**Work Plan for Further Site Investigation #4  
Hurricane Road Industrial Development / Former Houghland Tomato Cannery  
1130 East Eastview Drive  
Franklin, Indiana  
IDEM Site Identification Number 2013-34567  
Patriot Project No.: 20-0963-01E**

Appendix C – February 6, 2020 IDEM Comment Letter

Re: **Vapor Intrusion Investigation Report and  
Further Site Investigation 3 Review**  
Former Houglan Tomato Cannery  
1130 East Eastview Drive  
Franklin, Johnson County  
State Cleanup Site #201334567

**Figure 12**  
TCE Plume Map  
Shallow  
March 4-12, 2019

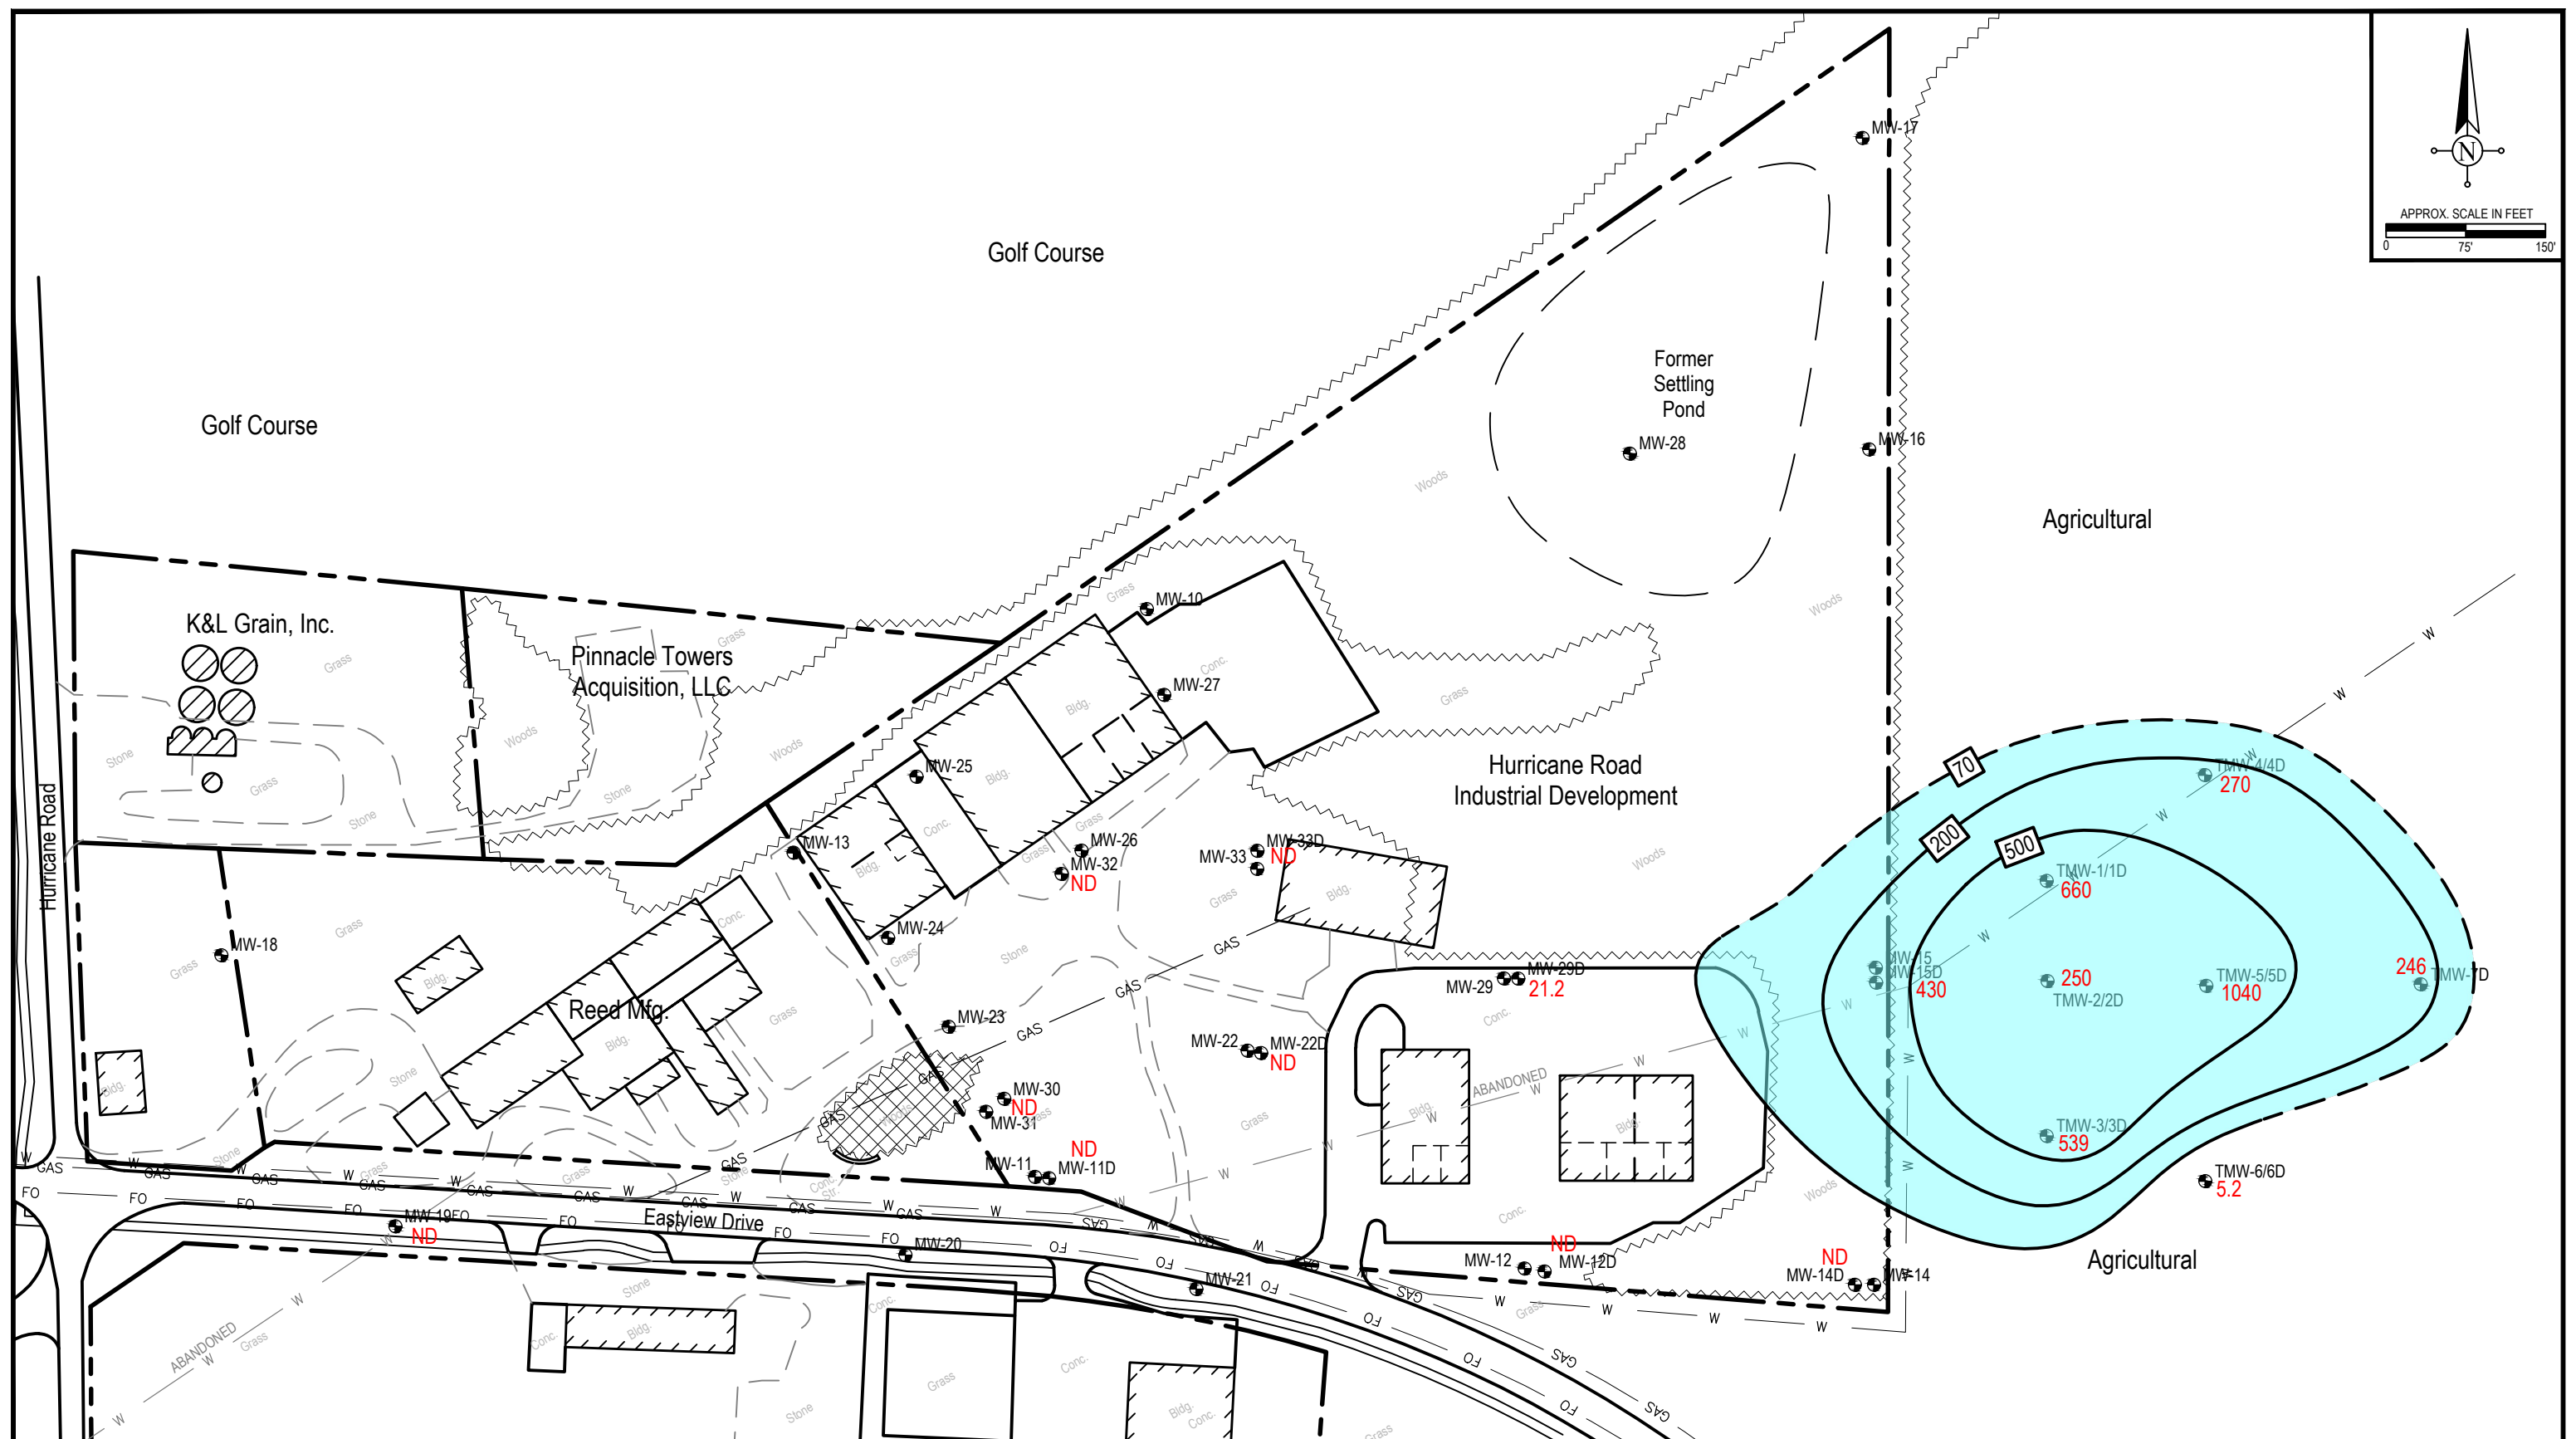
*IDEM Comment #4:* Figure 12 and Table 5 indicate the presence of TCE at the surface of the shallow aquifer at concentrations exceeding commercial vapor intrusion groundwater screening levels (VIGWSL) within the footprint of the gymnastics building

*on-Site. The gymnastics building has been evaluated for VI and TCE was not detected. Further evaluation of the VI pathway in the gymnastics building is warranted and has already begun.*

4. Figure 12 and Table 5 indicate the presence of TCE at the surface of the shallow aquifer at concentrations exceeding commercial vapor intrusion groundwater screening levels (VIGWSL) within the footprint of the gymnastics building on-Site. The gymnastics building has been evaluated for VI and TCE was not detected. Further evaluation of the VI pathway in the gymnastics building is warranted and has already begun.

Patriot has conducted the additional VI evaluation of the former gymnastics building. In addition, the gymnastics center vacated the property in early 2020 and the building is currently vacant. Depending on the planned future use of the building, additional VI evaluation may be necessary in the future but is not part of this Work Plan
